**From:** [REDACTED]  
**To:** [REDACTED]  
**CC:** [REDACTED]  
**Sent:** 2/24/2021 7:57:22 AM  
**Subject:** RE: O8W-PM [REDACTED] - Bucks Creek 1101 Phase 1,2&3 - Pre-Engineering Meeting

# Bucks Creek 1101- PM# [REDACTED] Overview Map

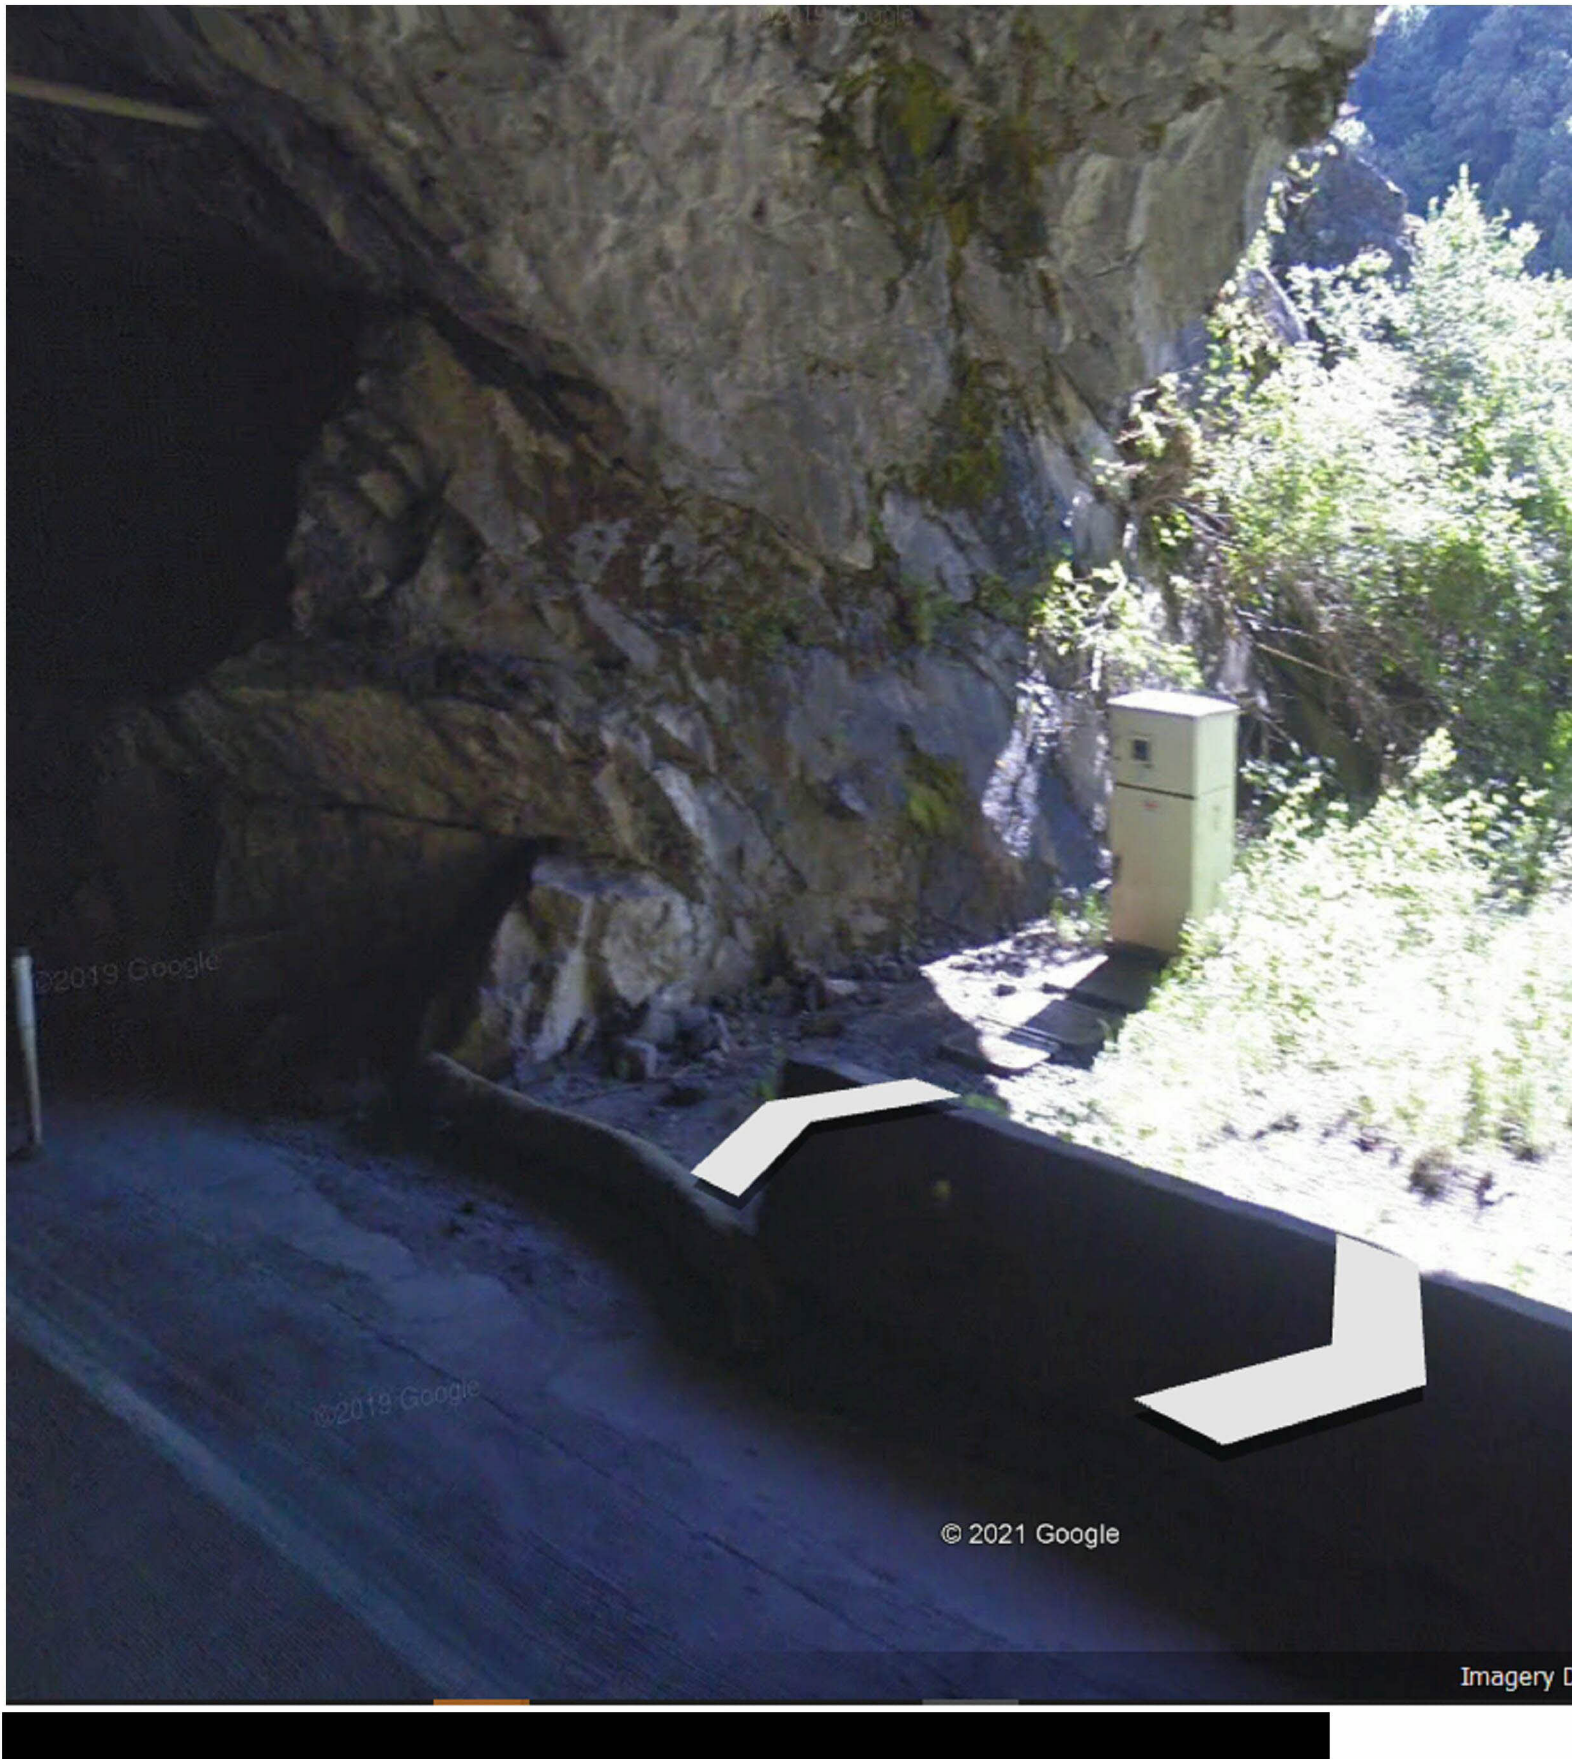
Attached are the 'base-map' limits in a kmz. file. As you will see, we need our base-map to go about ~100' into the tunnel at the south end (see pedestal in picture below....please begin about ~50 beyond this point which is about ~100' beyond the Cresta Dam).

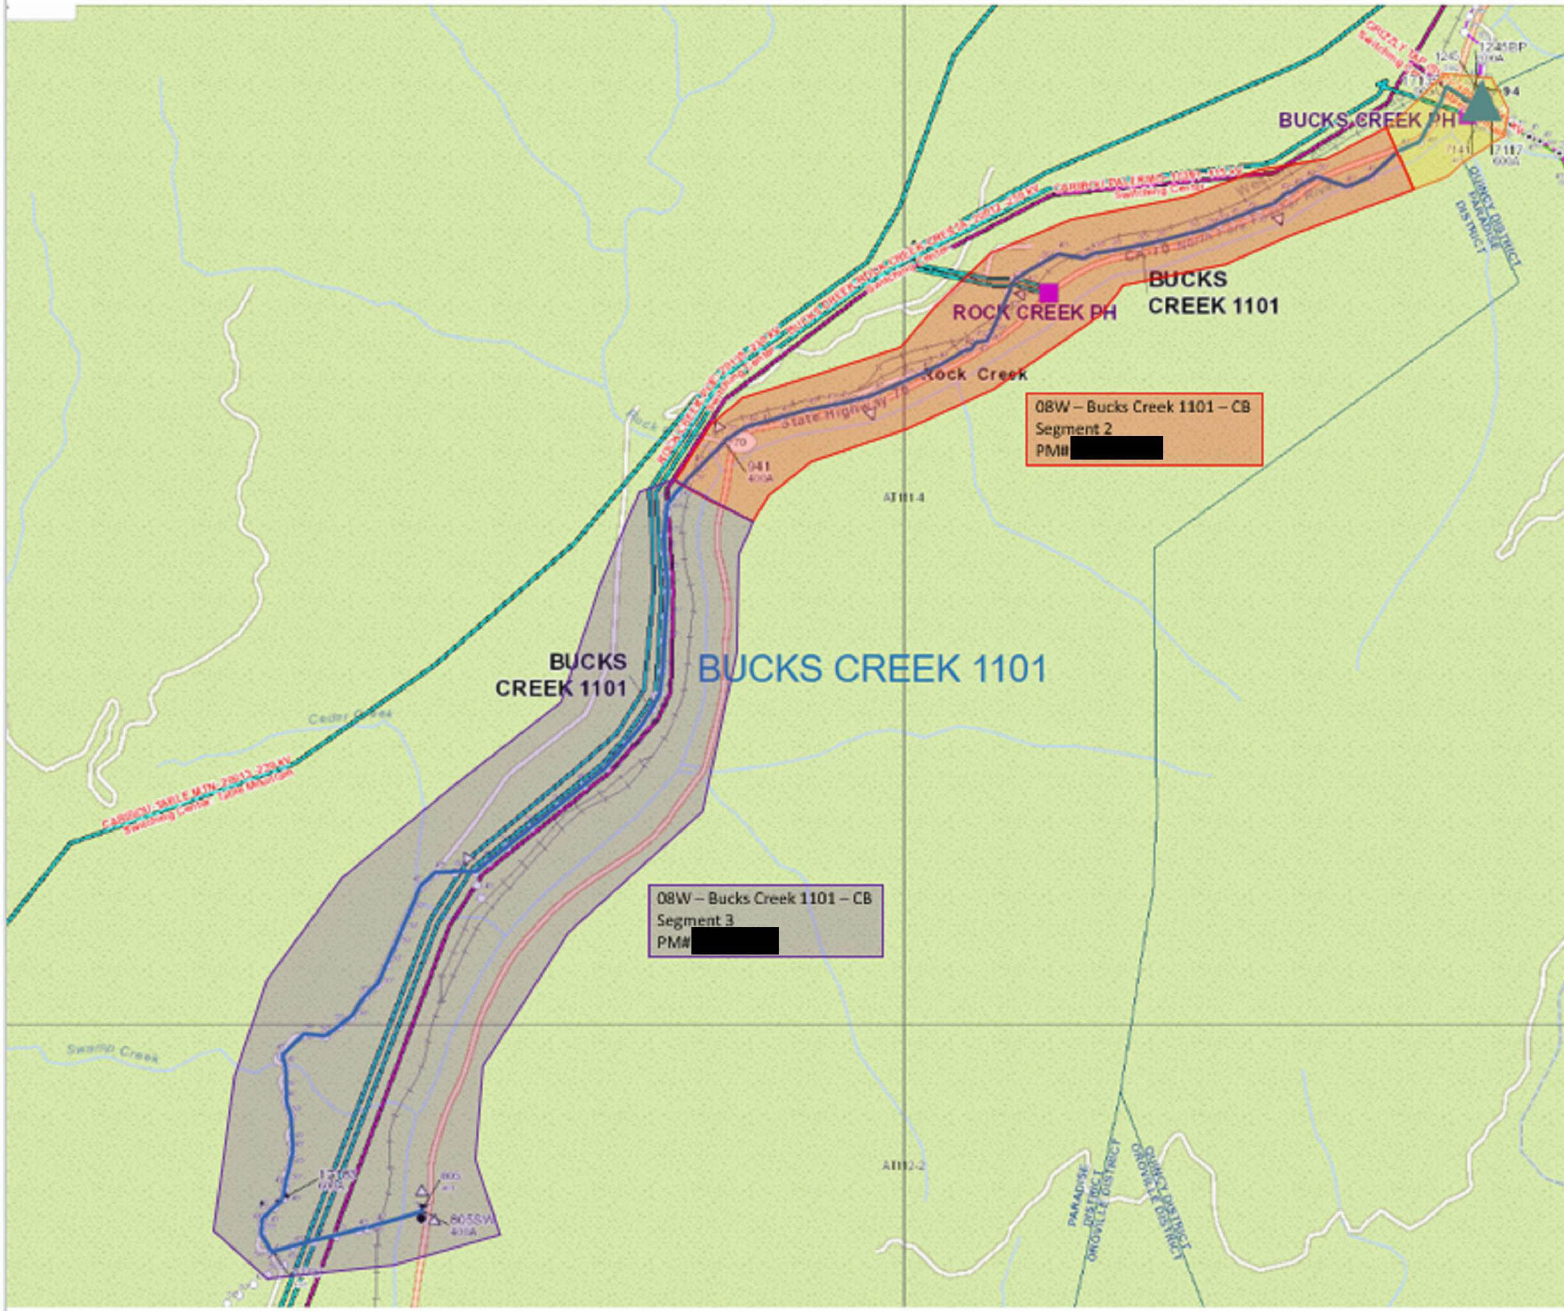
For Bucks Creek there is quite a bit of work surrounding Hwy 70 and we will need a Land Department Base Maps prepared for all 3 Orders. This will delay the EOD dates until these can be developed and provided to the Vendor... We will also need answers to the questions outlined by [REDACTED] below...
